2022/2255/P

Formal Objection Major Redevelopment at Great Ormond Street Hospital

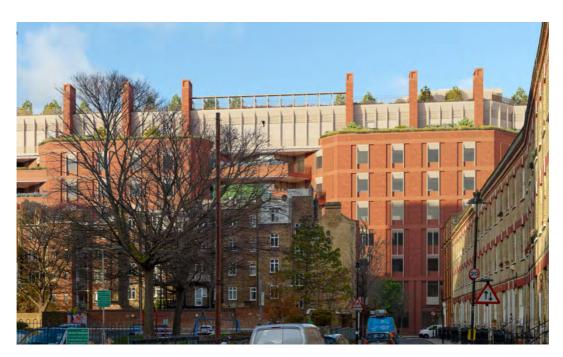
- 10. It is the opinion of the committee that the 'Paul O'Gorman Building' (shown below left) represents a useful baseline for the scale of development that might be acceptable, and that which is commonly found throughout the conservation area in direct juxtaposition with Georgian terraces. Subject to appropriate design, a building of this scale could be considered acceptable, with a potential for improved design to enhance the appearance of the conservation area.

- 11. The proposed scale of the development is however of almost twice the height of that building, and rises to a height far higher than any other building in the immediate block. The building line has been brought forward to the street boundary, and rises in a sheer vertical line with no appreciable set-back at any level.

- 12. In our view, a building of this scale would have a very considerable negative effect upon the immediate townscape, and in rising to approximately three times the height of opposing Georgian terraces, would clearly dwarf and overwhelm them. Indeed, the building is of the same height as the nearby Tybalds Estate tower block, which even in post-war planning, was set back many metres from the surrounding townscape to reduce its impact upon the small scale of the surrounding development.
